VALUE ENGINEERING MOD 1 TRAINING REPORT

Lithonia Industrial Blvd Extension – Phase III

Project No. CSSTP-0006-00(889)

March 11, 2009

STATE OF GEORGIA
DEPARTMENT OF TRANSPORTATION
OFFICE, GDOT DISTRICT 7
MAINLINE PLAN
Existing Configuration
LITHONIA INDUSTRIAL BLVD.

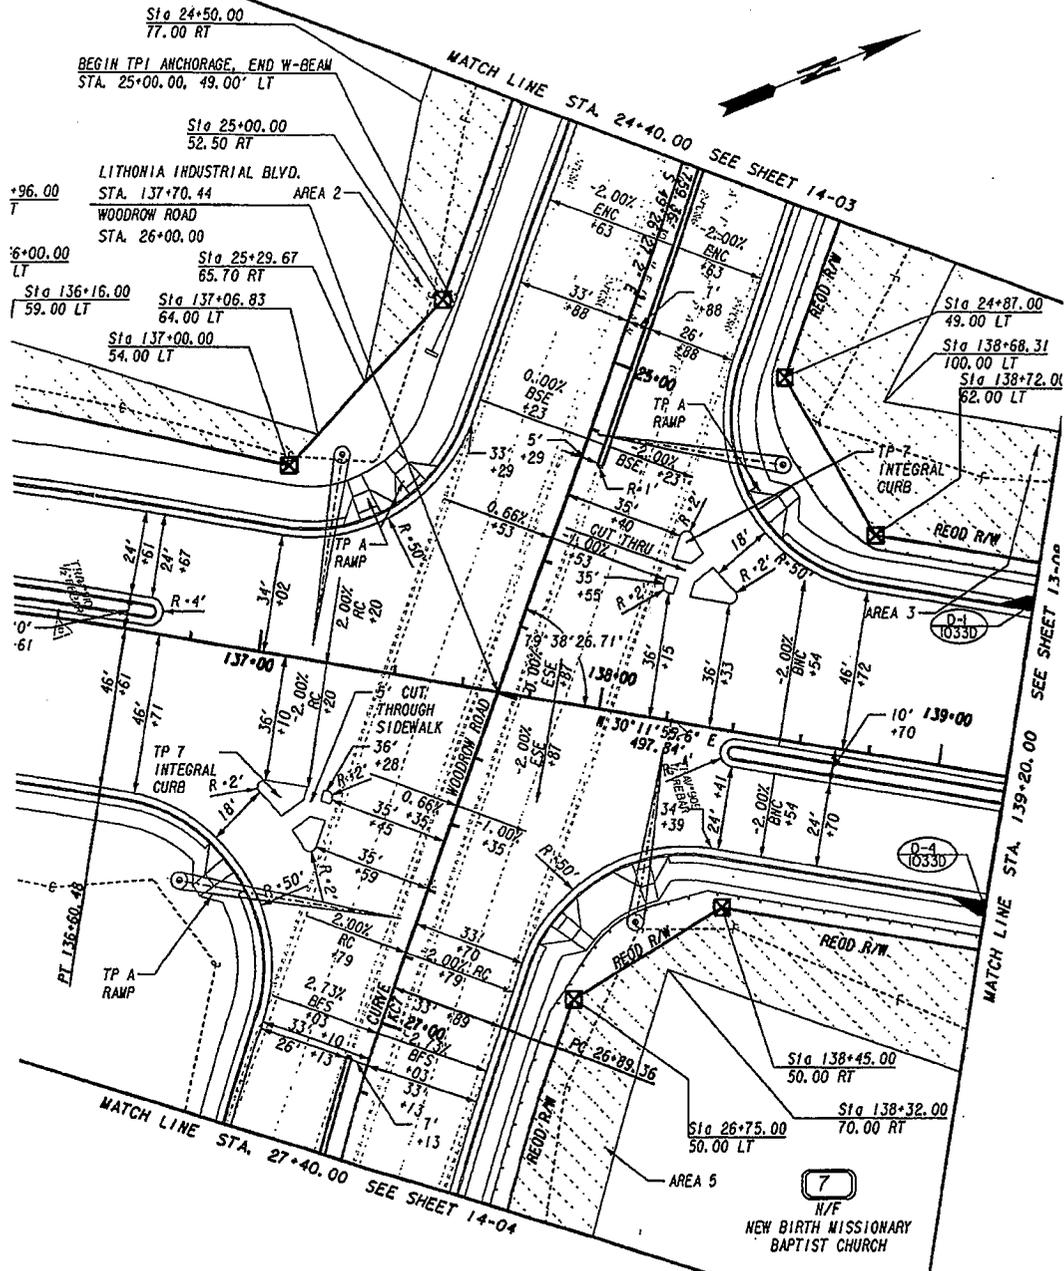
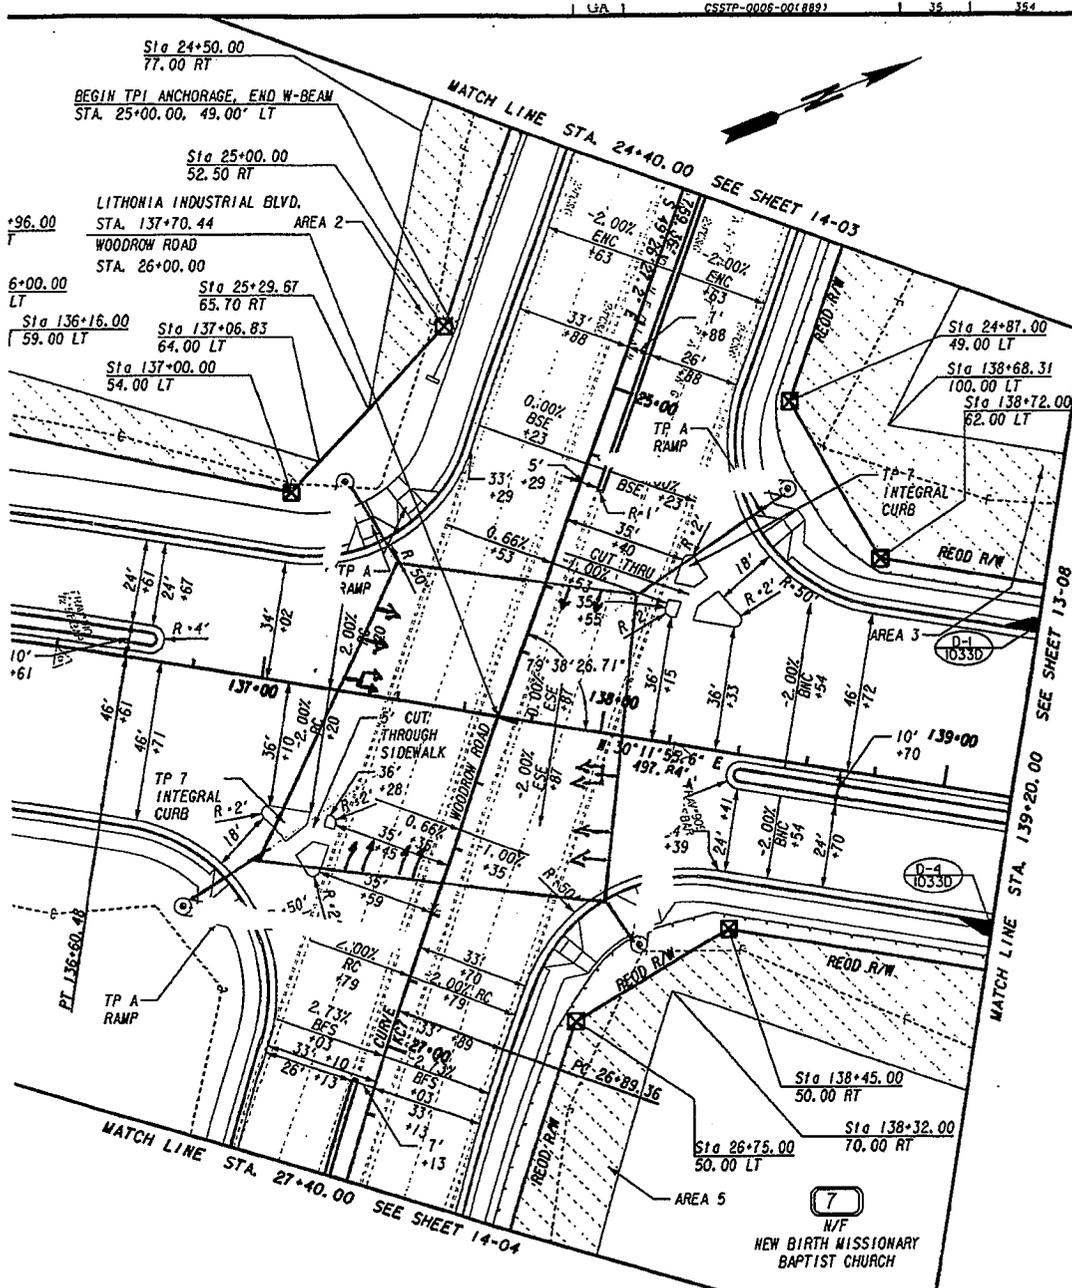
CREATIVE IDEA:
Revise Signal Support Configuration

Original Concept: The current project proposes new traffic signals at two locations. The project proposes to use steel mast arms for signal head supports.

Proposed Change: It is recommended that the signal support structures be revised from TP IV Steel Strain Poles with mast arms to TP IV Strain Poles with a “crushed box” signal span wire configuration.

Justification: The TP IV Strain Poles will function the same as the TP V with a cost savings.

SKETCH

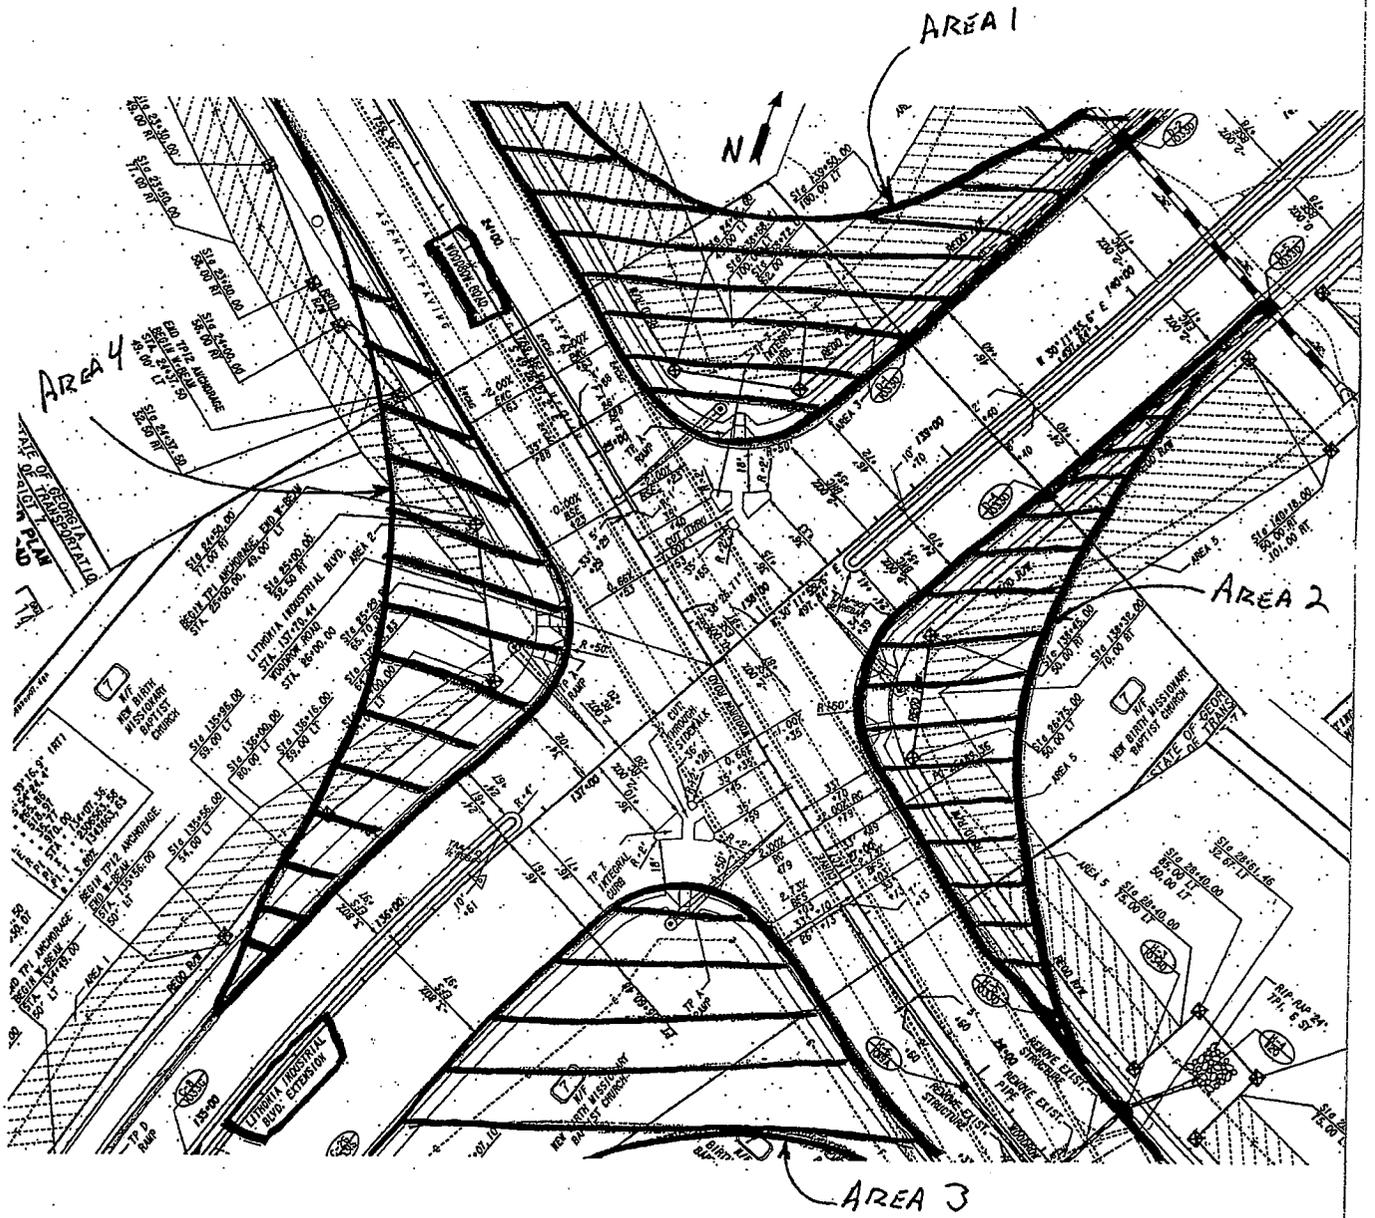
Idea No.: E-2	Sheet No.: 42 of 46	CREATIVE IDEA: Round About
-------------------------	-------------------------------	--------------------------------------

Original Concept: The project proposes to install a signal at the intersection of Lithonia Industrial Blvd. and Woodrow Rd.

Proposed Change: Recommend construction of a Round About and eliminate the signal at that location.

Justification: LIB and Woodrow Rd. are off-system roads. The majority of the turning movements at this intersection occur on Wednesday and Sunday for services at the New Birth Missionary Church. Traffic volumes along LIB are less than 16,000 ADT and the project is located on new location. Eliminating the signal reduces cost.

SKETCH

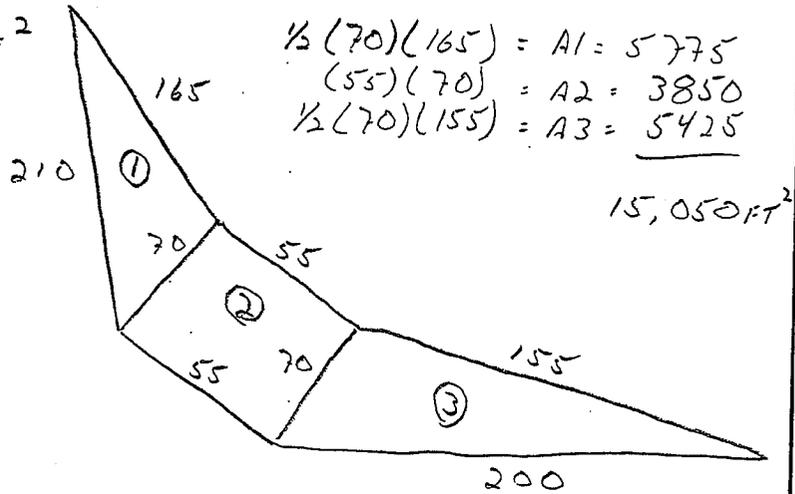
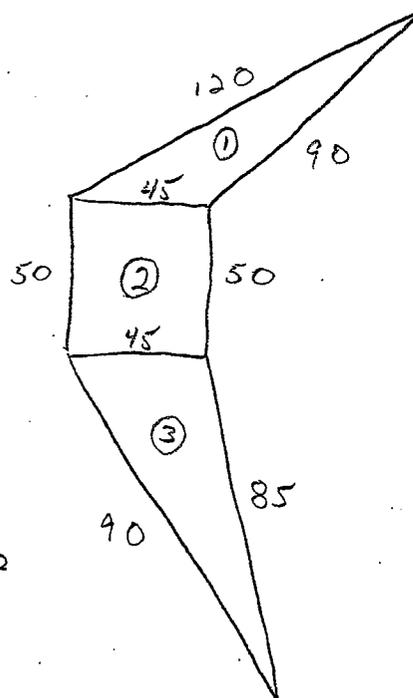
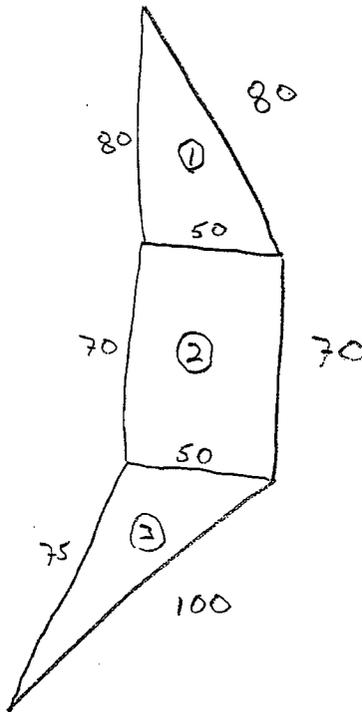
AREA 1: 15,050 FT²

AREA 2: 6,185 FT²

AREA 3: 0 NO ROW REQUIRED

AREA 4: 7375 FT²
